RE: Resubmission – File D08-02-241A-00066  
48 Nelson Street

This is a revised submission related to this application to respond to comments dated February 12<sup>th</sup> received from Penelope Horn and a request for a sine die adjournment of the application on February 19<sup>th</sup>. This letter should be read in conjunction with the original rationale dated January 6, 2025.

## Design Revisions

# Appendix B – Proposed Basement/Ground Floor Plan

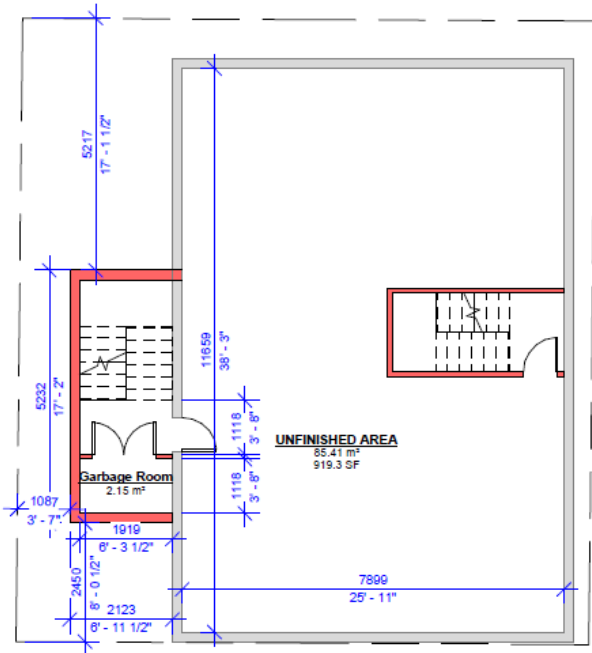
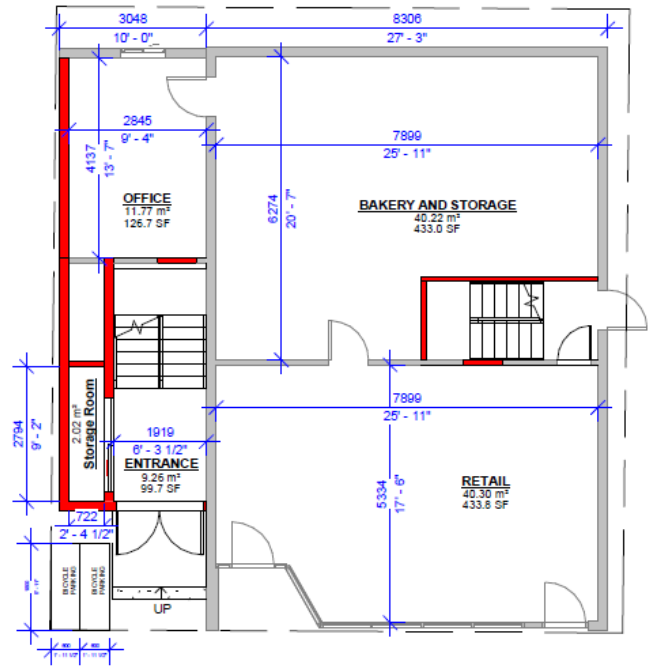
In response to comments regarding the provision of bicycle parking and for waste management storage, the site plan has been amended to include two horizontal spaces measuring .6 in width and 1.8 metres in length to the left of the entrance to the proposed residential units. The proposed spaces will comply with **Section 111 Bicycle Parking Space Rates and Provisions of By-law 2008-250** which requires .5 spaces per low-rise apartment dwelling unit. These spaces may be provided in any yard and are required to be easily accessible to the main entrance. (See Appendix A – Site Plan)

With respect to waste management storage, **Section 141 Residential Neighbourhood Commercial Suffix Subsection (9)** requires that *“Storage and refuse collection must be completed enclosed within a building”*. To accommodate this, the left (southern) wall has been extended to allow the proposed new stairway to directly access the basement level of the

building. A separate enclosed storage area has been provided on the basement level for the residential units. This change to the exterior has had a minimal effect on the overall look of the building.
